APPLICATION NO.	FILING DATE	FIRST NAMED INVENTOR	ATTORNEY DOCKET NO.	CONFIRMATION NO.
10/619,469	07/16/2003	Chen-Hung Hung	BHT-3107-120	7380
7590 03/22/2005			EXAMINER	
TROXELL LAW OFFICE, PLLC			LIN, TINA M	
Suite 1404 5205 Leesburg	Pike		ART UNIT	PAPER NUMBER
Falls Church, VA 22041			2874	
			DATE MAILED: 03/22/2009	5

DETAILED ACTION

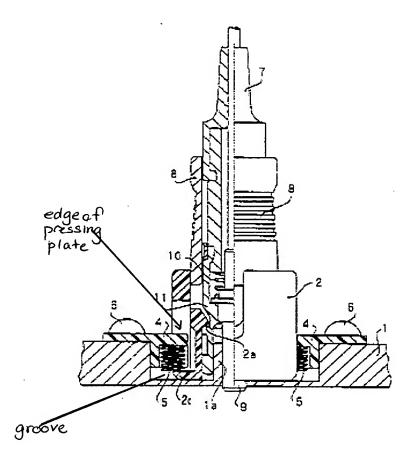
Yamada et al further fails to specifically disclose the moveable piece to be rotatable. However, by definition, the word rotatable means "to turn around on an axis or center." (*The American Heritage*® *Dictionary of the English Language, Fourth Edition*) Since the adapter hook part (2a) of the moveable piece rotates towards the adapter pressing plate, the moveable piece does rotate around a center defined by the lower right L-shaped portion. Therefore, it would have been obvious at the time the invention was made to a person having ordinary skill in the art that although Yamada et al does not specifically state the moveable piece rotates, Yamada et al does state the adapter groove portion to move towards the pressing plate and therefore rotates around the lower right center pivot point.
